SUBJECT: Forwards addl info requested re 950804 proposed TS changes  
re hybrid expansion joint sleeved tube repair boundary  
limits, in response to 950814 followup telcon & 950901 RAI.

AEP:NRC:1129G

Donald C. Cook Nuclear Plant Unit 1  
REQUEST FOR ADDITIONAL INFORMATION:  
TECHNICAL SPECIFICATION CHANGES REGARDING  
HYBRID EXPANSION JOINT SLEEVED TUBE REPAIR BOUNDARY LIMITS

3-Coil Profile of HEJ with Parent Tube Indication

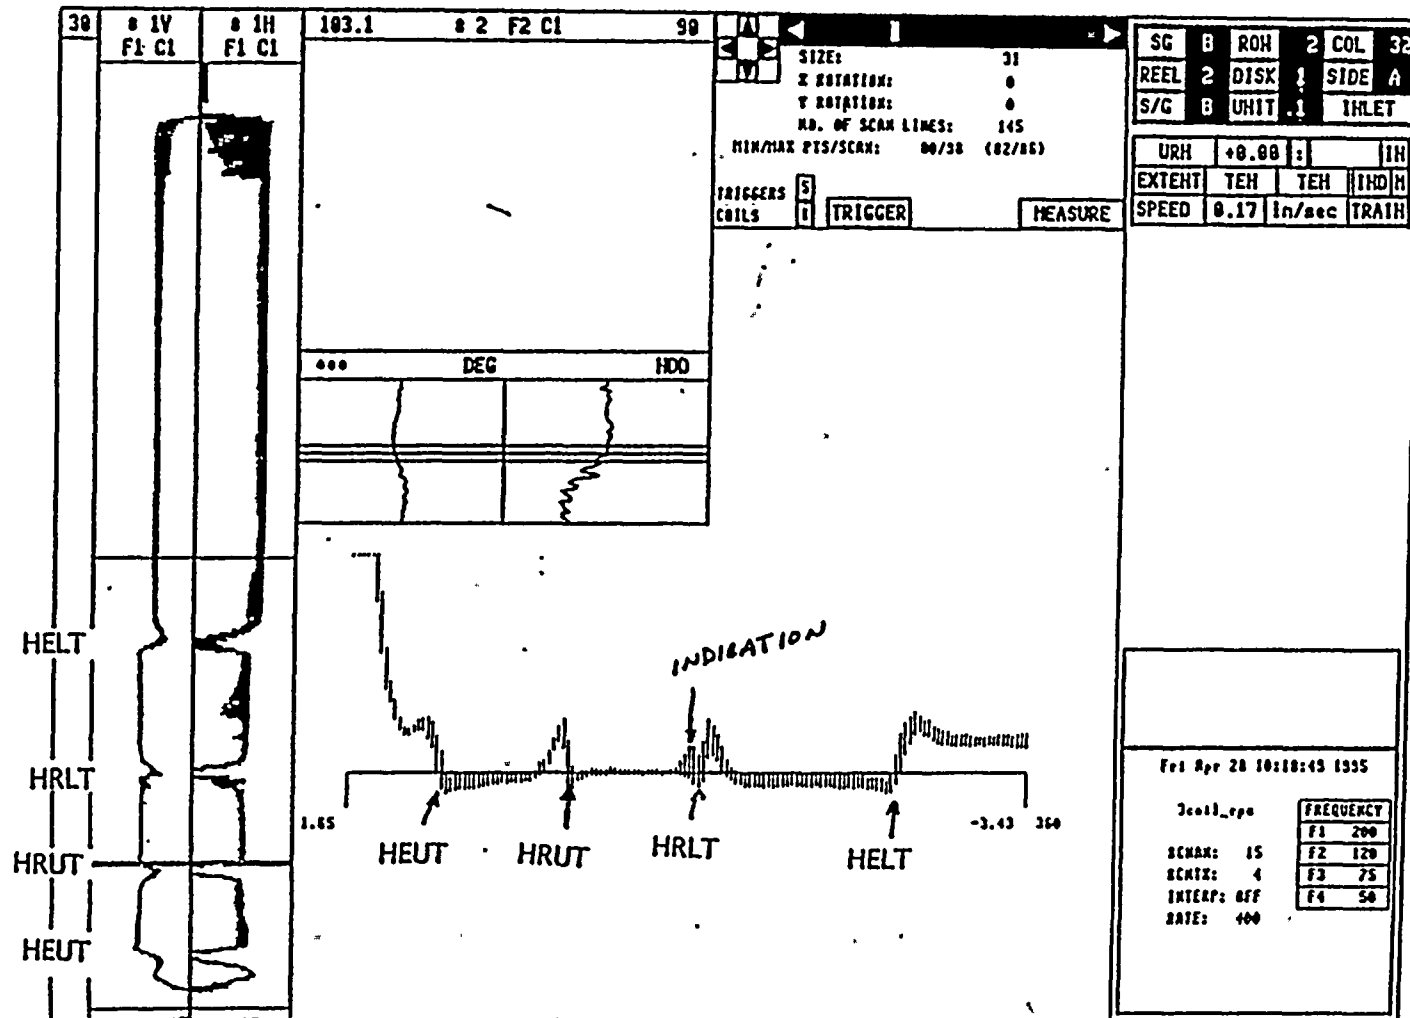
**QUESTION 1:** Provide details regarding the establishment of the 0.06 uncertainty applied to the location characterization of indications with reference to the bottom of the hard roll upper transition.

Figure 1 shows RPC pancake coil data of a typical HEJ configuration in axial profile. The strip chart and the profile C-scan are labeled with the main features of the joint: the upper and lower transitions of the hydraulic expansion (HEUT and HELT, respectively), and the upper and lower transitions of the hard roll (HRUT and HRLT, respectively). All features of the HEJ are evident to the analyst. Figure 2 shows the same sleeved tube using a Plus Point probe.
